SE-4734

TECHNICAL STAFF REPORT:

SUBJECT: **Special Exception Application No. SE-4734**
Mill Branch Crossing (Walmart)

RECOMMENDATION: **DISAPPROAL**

OVERALL SITE PLAN

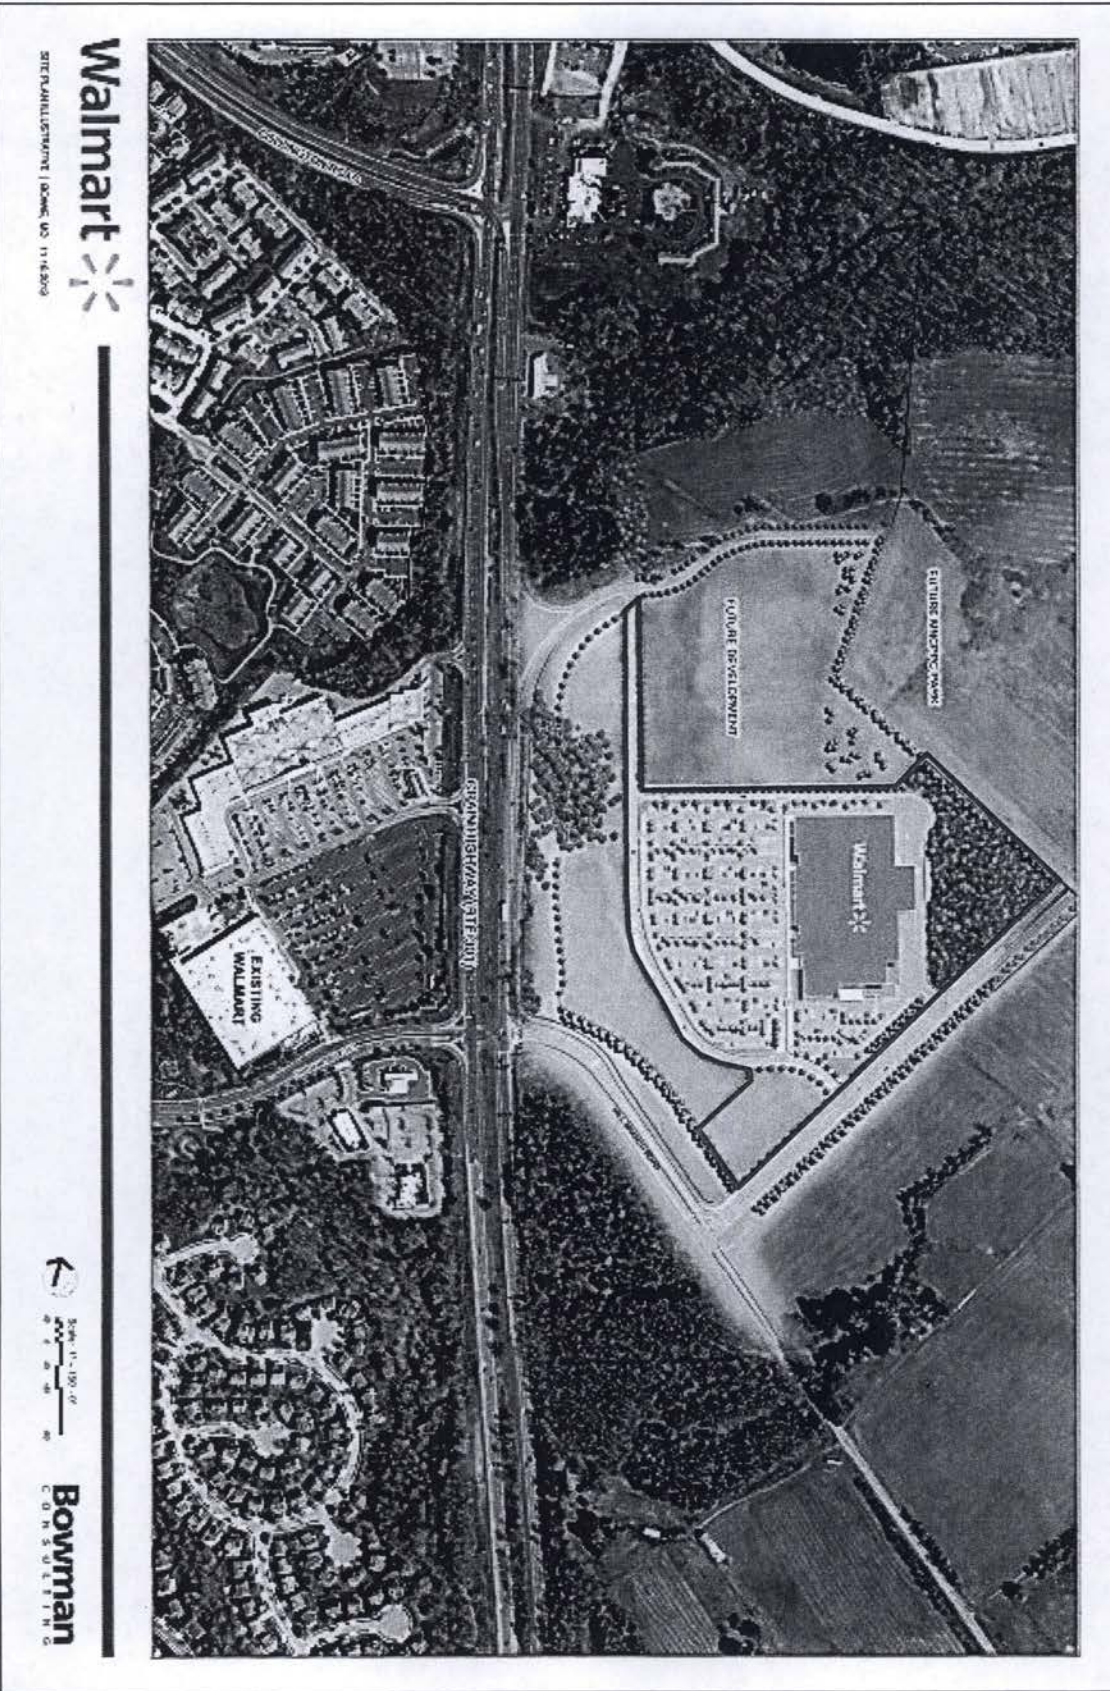
The plan does show the existing 50-foot-wide easement along the southeastern property line and, in fact, proposes an additional 62-foot easement to M-NCPPC, all of which is in an area not included in the special exception. However, it does provide for access to the proposed development and will be the primary access for trucks and customers travelling south on US 301. The applicant has not explained how they intend to meet the second guideline or when this temporary easement will be replaced by a permanent right-of-way.

DPR staff believes that it should be noted that the access drive from Mill Branch Road shown on the special exception plan will serve both Walmart and Green Branch Park from Mill Branch Road, but this access drive was not included in the special exception application. During the Subdivision and Development Review Committee meeting held on August 2, 2013, DPR staff made a request to revise the boundaries of SE-4734 to include the access drive as part of the special exception because the drive will provide an important vehicular access to Wal-Mart from Mill Branch Road and because it is needed to facilitate the development of the public park. The September 23, 2013 resubmission of SE-4734 does not include the access drive as part of the special exception.

The applicant has shown a "proposed 62-foot easement to M-NCPPC" in the submitted plans, but has not included the easement within the boundaries of the special exception, or requested that the existing 50-foot easement be relocated to the proposed 62-foot easement area. We are assuming that the applicant intends to request relocation of the existing 50-foot-wide easement, which is currently located along the southeastern property line. While DPR has no objection to the applicant's proposed commercial development on this property, the owner of the property has not addressed the need to relocate the existing 50-foot easement that was executed to provide joint access to the adjacent parkland from Mill Branch Road.

As presently configured, the subject property does not have frontage on or access to an arterial roadway. The site plan shows frontage on an entrance drive off of Crain Highway (US 301) which is proposed to be dedicated to the Maryland State Highway Administration. If this dedication were to transpire, this would satisfy this requirement. The secondary access is to a driveway from Mill Branch Road within an area proposed as an easement to M-NCPPC for shared access to the park property to the east. This section of Mill Branch Road is classified as a local collector, not a primary or secondary street.

The submitted plan indicates five loading spaces being provided at the rear of the building in the southeastern corner of the site. The loading spaces are shown to have a separate driveway cut from the shared driveway for the shopping center and regional park. The location of these loading spaces, separated from the customer parking lot, and the provision of a special "Customer Loading Area" in the front of the building on the submitted plan demonstrate conformance to this requirement.

ELEVATIONS

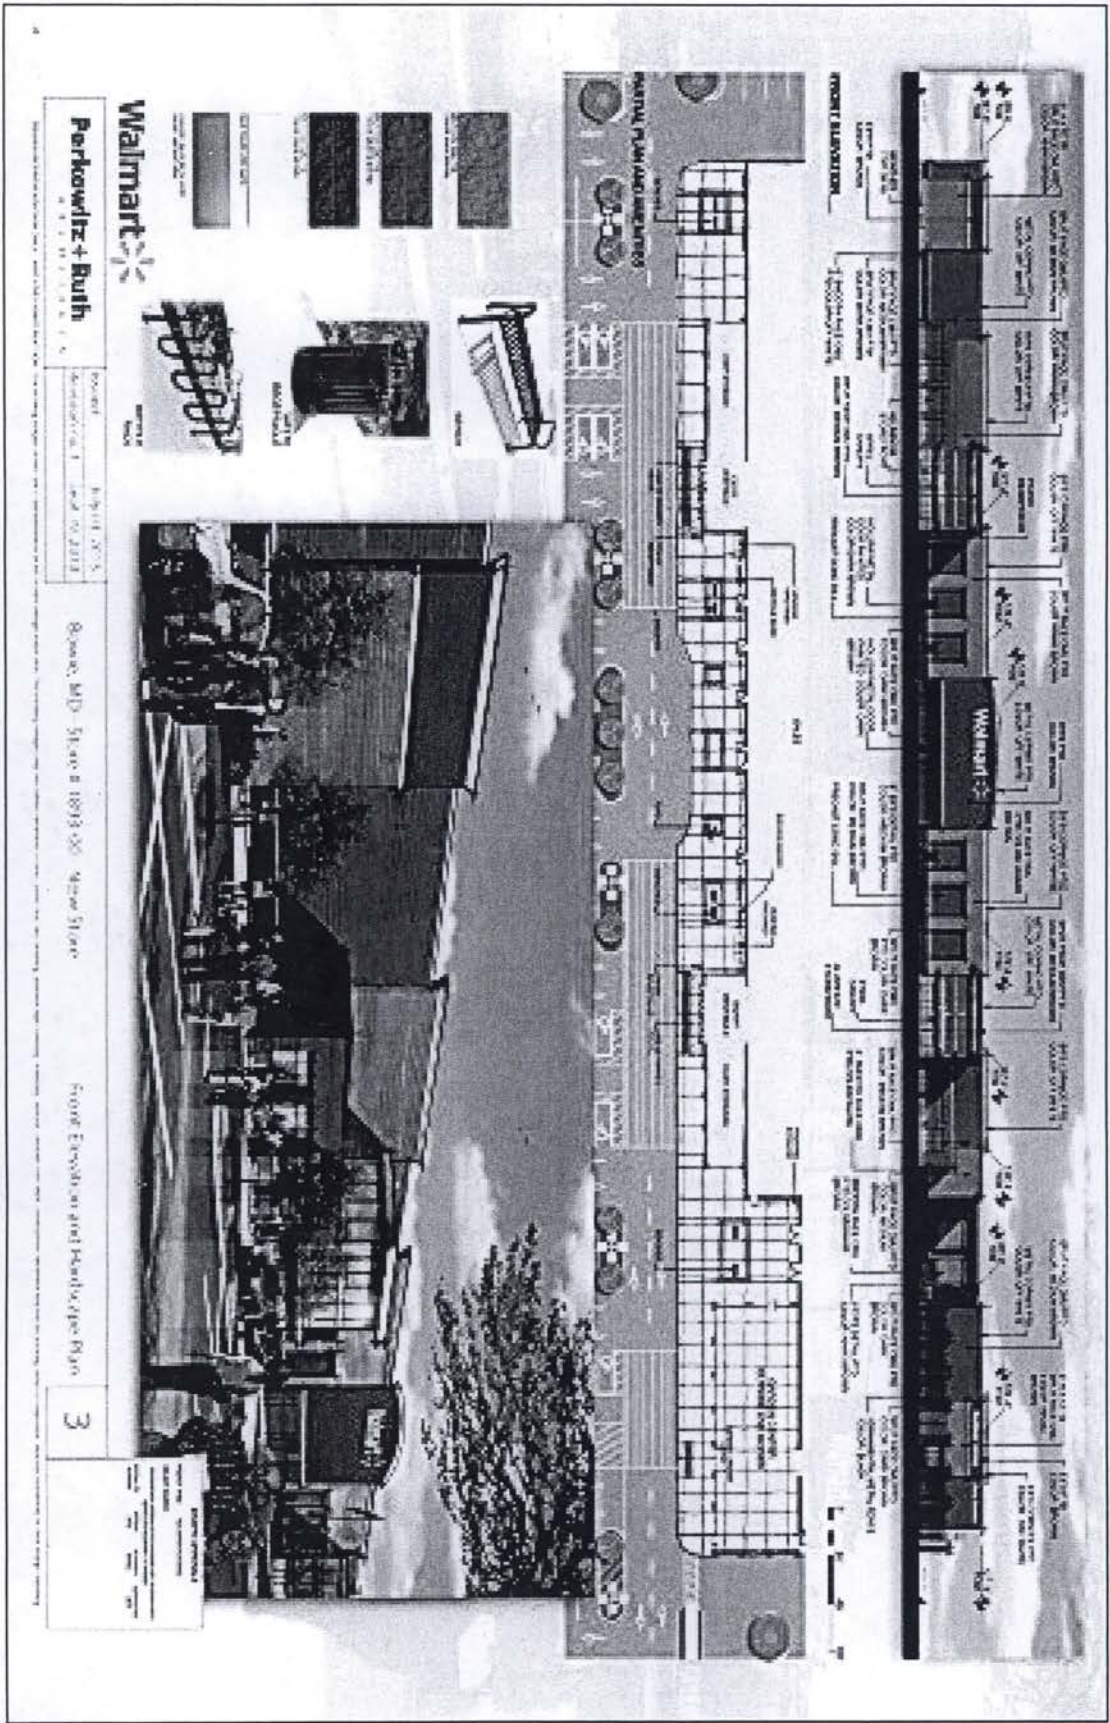
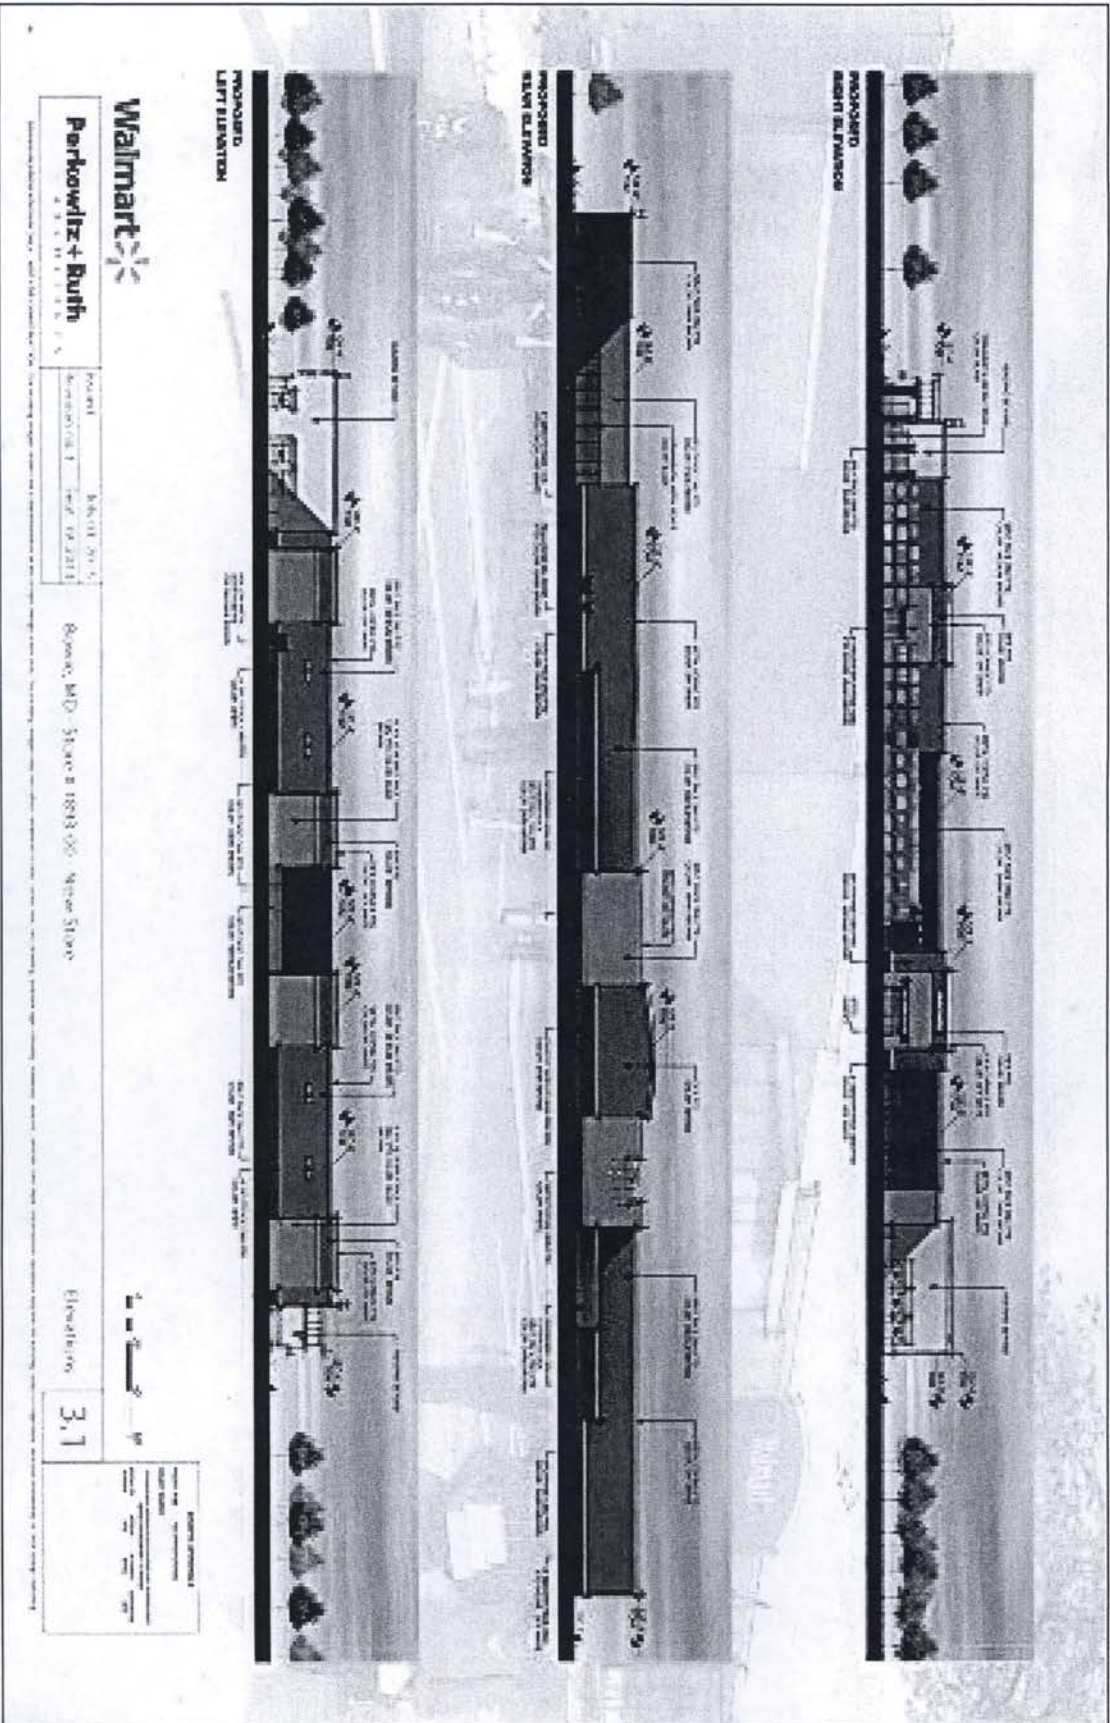
The proposed architecture for the subject project, rather than enhancing compatibility with existing commercial and residential in the vicinity of the subject project, sets the bar dangerously low for acceptable architecture and provides an undesirable design precedent for future development in the area. More particularly, the architectural features of concern include the following: materials, form, massing and roof articulation, and use of architectural detail and ornament, or lack thereof. Each is discussed individually below in greater detail:

- Materials for the proposed building include almost exclusively EIFS and CMU, both known in the industry as inexpensive and inferior quality materials. A small amount of metal coping and ornamental fence is utilized in the design; however, on a building this large, its quantity does not create a design element of significance. The addition of brick or cementitious siding (both higher quality more durable materials) would add a sense of quality and permanence to the development and the addition of a standing seam metal roof, or other significant contrasting quality architectural material, would provide more visual interest to the architectural composition.

- All of the façades of the building should receive at least the same level of architectural treatment as the front façade as they will be highly visible from the approach road to and the adjacent parkland itself. The proposed rear and left elevation façades, though offering some variation in color of both the CMU and EIFS, otherwise provide little architectural variation that would create visual interest and an aesthetically pleasing aspect. The regular application of architectural detail, noticeably absent from the overall architectural composition, would greatly enhance the design.

Staff finds the proposed architecture to be insufficient to set the tone for the type of quality development envisioned by the master plan. Staff is particularly concerned that the architecture of the southern and eastern walls facing the Rural Tier and the park property, respectively, do not show an imaginative or aesthetically-pleasing treatment.
